Development Review Comments

PAM2024-00152

622 Hungerford Drive – Washington Square

WASHINGTON SQUARE
PRE-APPLICATION SITE PLAN
CITY OF ROCKVILLE, MARYLAND

PSP-01

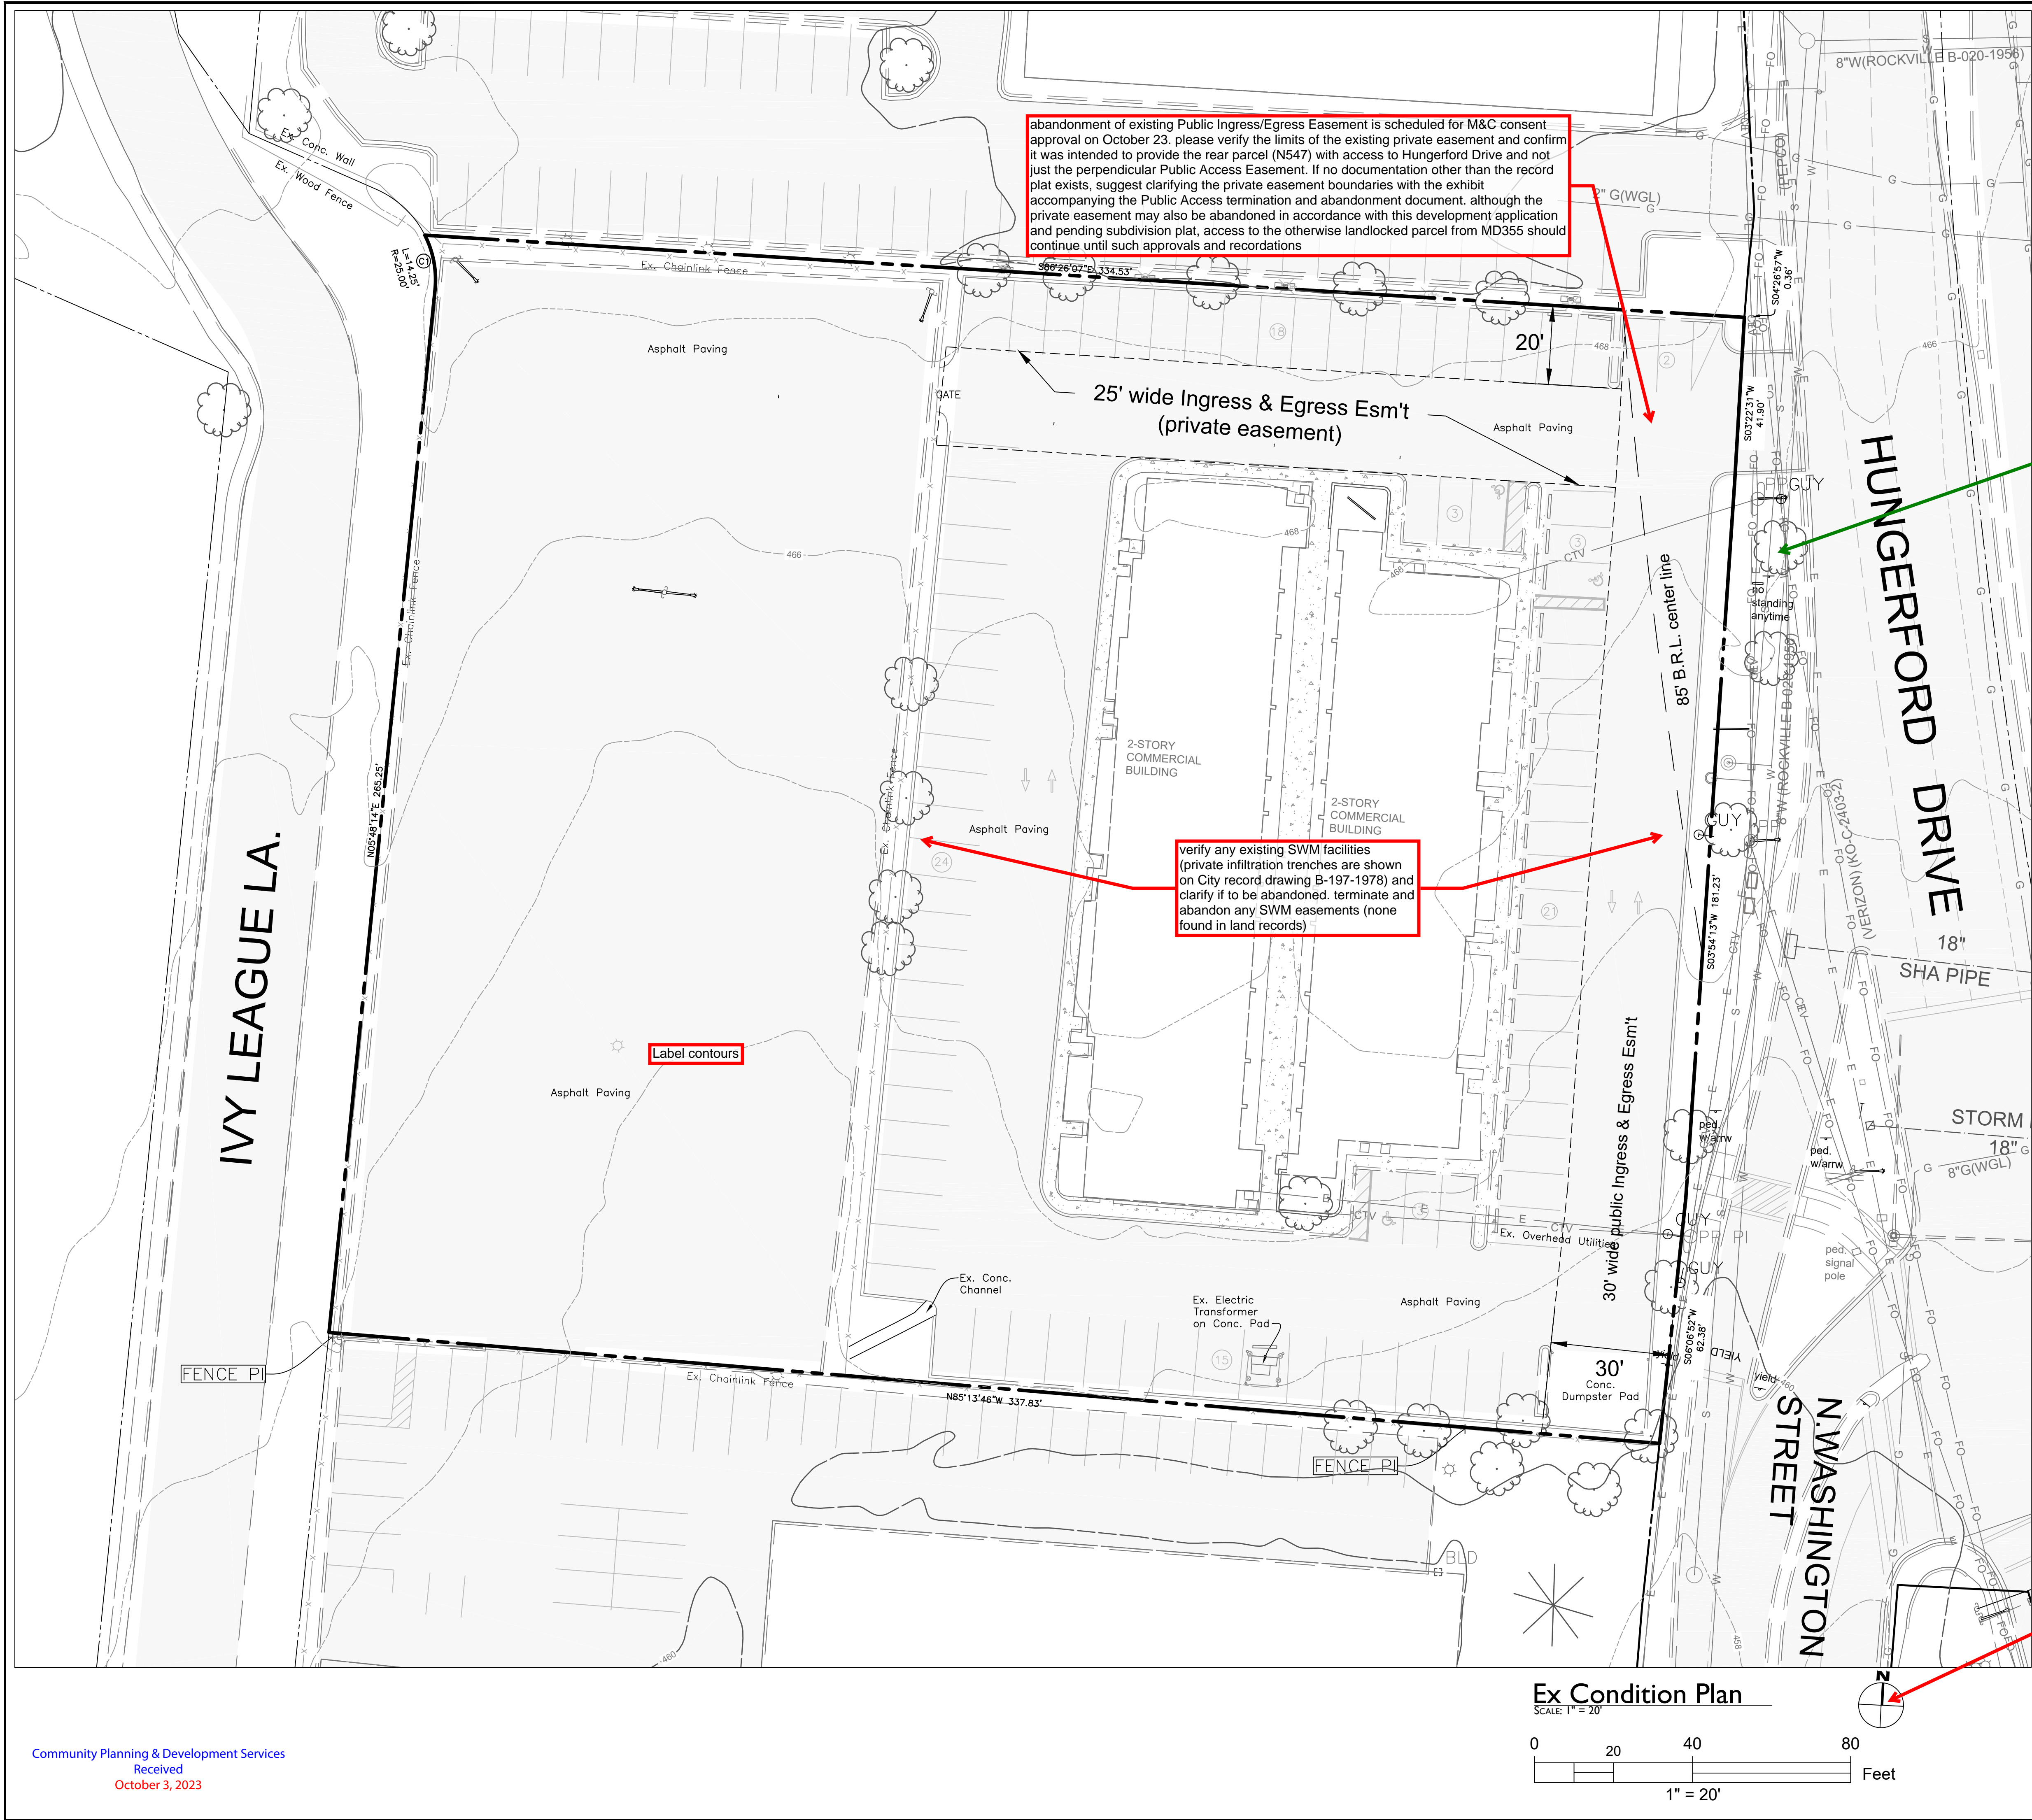
Please note that street trees along Hungerford Drive will need approval from the State Highway Association for removal

Provide datum

PSP-02

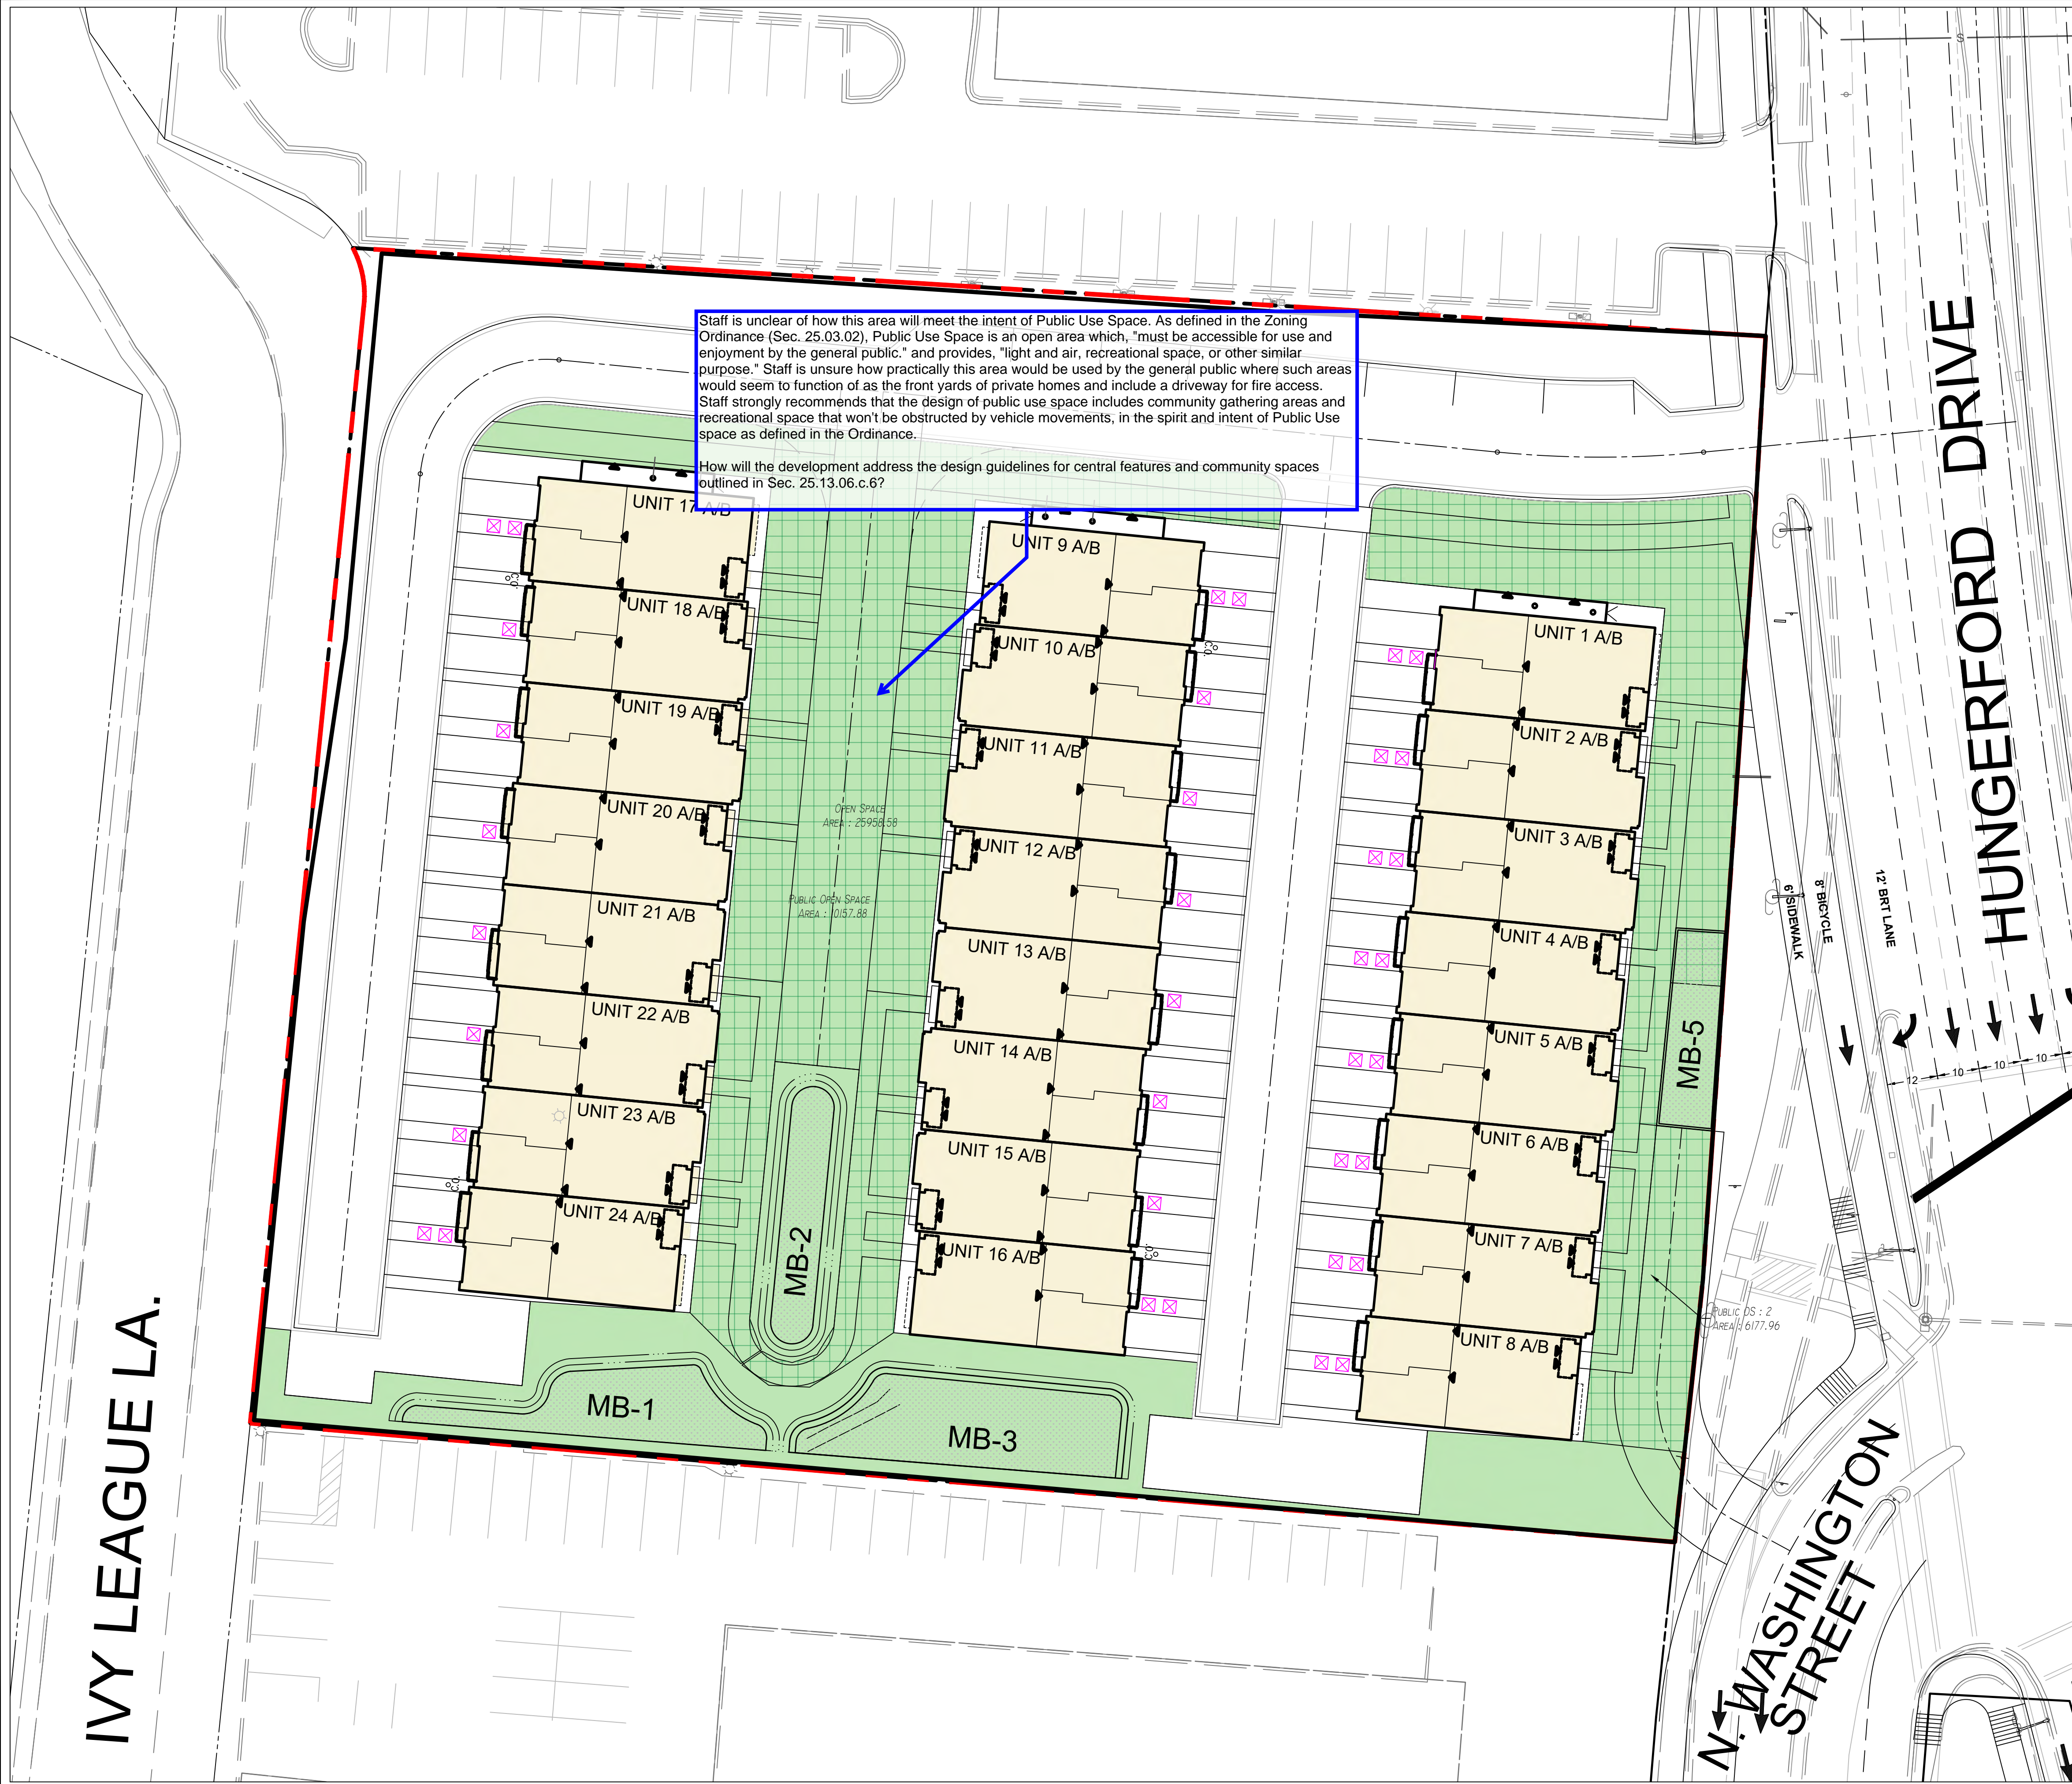
if individual water service is to be internally plumbed, will sewer as well? verify building code requirements for onsite laterals

Staff strongly recommends that in providing short-term (for deliveries and loading) and visitor parking due to lack of on-street parking on Hungerford Drive and Ivy League Lane. Are the 8 on-street parking spaces intended strictly for visitor parking?

Per Sec 25.16.06.b.1.(a), parking spaces must be dimensioned at least nine (9) feet wide and eighteen (18) feet deep.

Water meters, including location and settings, shall be installed in an easement dedicated to the City, as close to the ROW/private property boundary as practicable and preferably within a grass area

private refuse collection shall be provided in accordance with Chapter 20 (Sec. 20-8 & 20-9), applicant must clarify operation, whether each unit is supplied with bins and individually collected adjacent to the driveway, or centrally collected in dumpsters. centralized collection subject to screening requirements (Sec. 25.17.02.) and location must be designated on plans. decentralized collection must not block traffic, parking or access

Per Sec. 25.16.06.c.2, driveway must be a minimum of 25' in width. Additional width may be required by Fire.

access to MD355 must be coordinated with SHA and BRT

In FCP submission, please demonstrate how impacts to off-site trees will be minimized.

On-site sidewalks must be provided between the public right of way to each entrance and must be 6' wide per Sec. 25.13.06.c.5

Clarify materials to be used for access lane

two AC units for each 2-over-2?

Per Sec. 25.13.06.b.6, mechanical equipment must be screened to mitigate noise and views in all directions.

As parking spaces for dwelling units will be accessed from these internal drive aisles, such drive aisles must be 24' wide, per Sec. 25.16.06.a.(1).(a)

Parking spaces must comply with City standards ((Sec. 25.16.06), and must be at least 9' wide and 18' deep. If driveways are to be used as required parking they must meet these dimensions.

On-site sidewalks must be 6' wide per Sec. 25.13.06.c.5

Turning movements for access and loading must be accommodated onsite. Provide turning movements from drive aisle into driveways.

provide sidewalk connection to N Washington

Per Sec. 25.16.06.h.2, maneuvering area must provide a turning radius of not less than 48'. Additional area may be required by Fire.

It is unclear how a loading truck would access and/or turn around in these spaces. Provide updated turning templates for largest expected delivery/moving vehicle (e.g., SU-30 truck)

For improved circulation, staff recommends that these two drive aisles be connected by an intervening driveway, which must be a minimum of 18' in width (Sec. 25.16.06.a.2). Minimum width required by Fire is 20'.

Provide typical lot detail demonstrating how all utilities (wet & dry) will connect to units. water meters and cleanouts cannot be in driveways

On the site plan, show the interim condition that needs to demonstrate compliance to the bikeway master plan which calls for a 10 foot wide cycle track with a separate sidewalk

Move the linework for BRT to a separate exhibit that will show the ultimate condition.

dedication of public right-of-way is required to accommodate future MD355 BRT (dashed line). a 2' buffer behind the 6' sidewalk is shown on BRT plans

Subsequent application will be coordinated with MCDOT, SHA to verify future maintenance responsibility of MD355 sidewalk (if not private maintenance with access easement)

Confirm if bicycle parking is proposed.

note incomplete?

WASHINGTON SQUARE
Pre-Application Site Plan
Confirm the proposed building setback from Hungerford Drive centerline.
Typo
WSSC Grid: 219NW07, Tax Map: HN23
City Of Rockville, MD, Rockville, Election District 04

ISSUE DATE
2/ Narrative indicates 2 spaces per unit; if this includes the 8 on-street spaces then the total is 104
